DEVELOPMENT APPLICATION ASSESSMENT REPORT

Application Number:	DA2024/1698	
sponsible Officer: Anaiis Sarkissian		
Land to be developed (Address):	Lot 108 DP 1294859, 71 Florida Road PALM BEACH NSW 2108	
Proposed Development:	Demolition works and construction of a dwelling house	
Zoning:	C4 Environmental Living	
Development Permissible:	Yes	
Existing Use Rights:	No	
Consent Authority:	Northern Beaches Council	
Land and Environment Court Action:	n: No	
Applicant:	Sean Clive Gartner	
Application Lodged:	20/12/2024	
Integrated Development:	No	
Designated Development:	No	
State Reporting Category:	Residential - Single new detached dwelling	
Notified:	13/01/2025 to 27/01/2025	
Advertised:	Not Advertised	
Submissions Received:	1	
Clause 4.6 Variation:	Nil	
Recommendation:	Approval

Figure 8: Submitter's depiction of established front building line

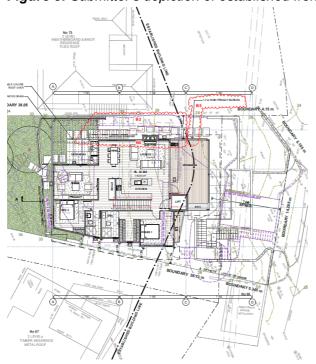
The proposed dwelling sits almost entirely behind the established front building line depicted in Figure 8 below, with the exception of the garage and verandah. The garage is consistent with other parking structures within the front setback along the Florida Road streetscape, and has an increased setback from the front boundary in comparison to the car parking structure of the two adjoining properties, which sit on the front boundary line. The lot itself protrudes further than the nearby lots and the verandah is an unenclosed structure with a minimum setback of 7.5m from the front boundary. The dwelling is limited in its siting further towards the rear of the site owing to the lot width narrowing towards the rear and the presence of trees and rock outcrops (refer Figures 8 and 9), which would require removal and additional excavation given the elevation at the rear.

Figure 12: Amended site plan

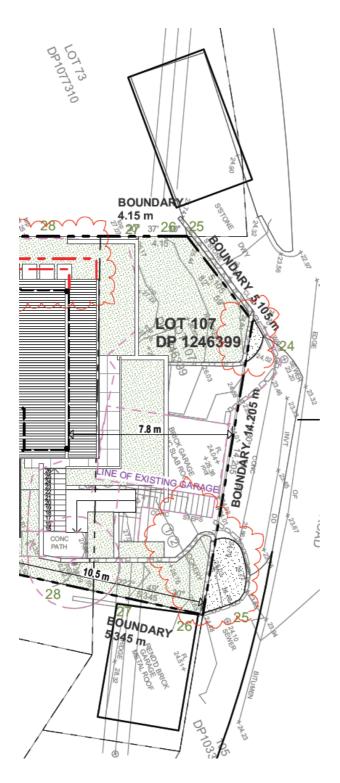
It is important to note that the existing garage on the site, as well as the garage on the adjoining property at 69 Florida Road and the carport at 73 Florida Road sit on the front boundary with no provision of front in and front out access. By contrast, the proposed garage has a ranging setback between 2.7m and 3.7m from the front boundary. Additionally, the amended plans remove the existing stone retaining walls from within Council's road reserve and propose to rebuild them within the boundaries of the subject site, thereby improving access to both 71 and 73 Florida Road. Refer Figures 10-12.

Figure 19: Amended NW elevation

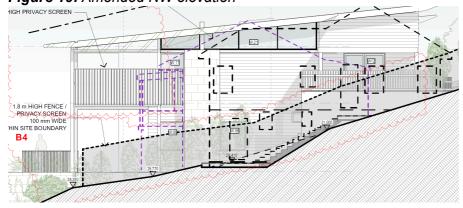
The windows and private open space areas of the proposed dwelling are located approximately 3.8m to 6.5m from the windows of 73 Florida Road to the north-west. The amended plans submitted on 25 March 2025 include the provision of 1.7m high privacy screening along the entire north-western edge of the verandah at the upper level, thereby eliminating overlooking to 73 Florida Road from both the verandah and Window 11. The balustrading to the rear courtyard is at a height of 1.55m, with half of this being screened by a 1.8m high fence proposed to be located wholly within the boundaries of the subject site, approximately 100mm off the common boundary. This new fence mitigates potential privacy impacts from windows 5 and 6. Refer Figure 19 below.

Figure 20: Interface between 71 and 67 Florida Road

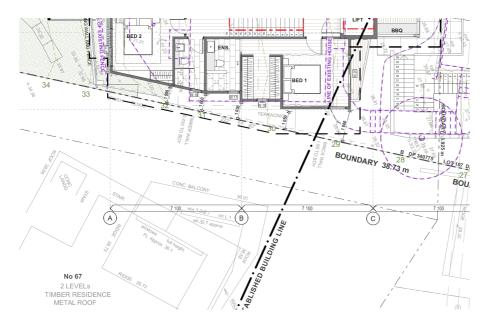
With respect to privacy impacts to 67 Florida Road to the south-east, the windows at the south-eastern elevation are not excessive in size and are to bedrooms, bathrooms and a walk-in wardrobe, which are all low-activity rooms. The separation distance between the proposed dwelling and the dwelling at 67 Florida Road is approximately 6m. It is important to note that the battle-axe handle for 69 Florida Road and the angle of the properties not being parallel minimise potential privacy impacts (refer Figure 20).

Figure 24: Amended NW elevation

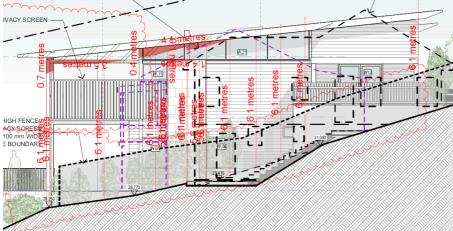
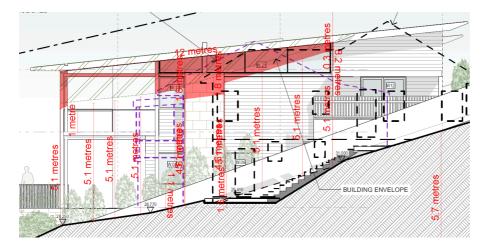
The north-western elevation presents an encroachment of between nil and 0.1m in height for a length of 1.4m, an encroachment of between nil and 0.7m in height for a length of 3.5m, and an encroachment of between nil and 0.4m in height for a length of 4.1m, resulting in a maximum variation of 11.5% (0.7m), as shown shaded red at Figure 24 below. It is important to note that the building footprint is situated on a slope of approximately 35%, and the roof has been designed to follow the slope of the land, reducing the protrusion of the dwelling outside the building envelope.

It is also important to note that amended proposal is now largely compliant with the side setback to the north-western boundary, and the original proposal presented a far greater non-compliance with the building envelope. The original design presented an encroachment of between 0.3m and 1.8m in height for a length of 12m, representing a maximum variation of 39% (1.8m), as shown shaded red in Figure 25 below.

Figure 26: SE Elevation

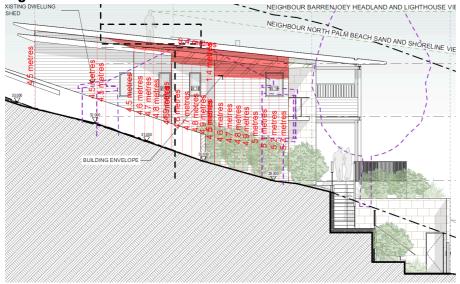
The south-eastern elevation presents an encroachment of between nil and 1.4m in height for a length of 9.4m, resulting in a maximum variation of 28% (1.4m), as shown shaded red in Figure 26 below. This variation is considered acceptable owing to the steep sloping topography of the land, the lack of amenity impact, the adjacent battle-axe handle and the compliant setback of the building with the south-eastern boundary.
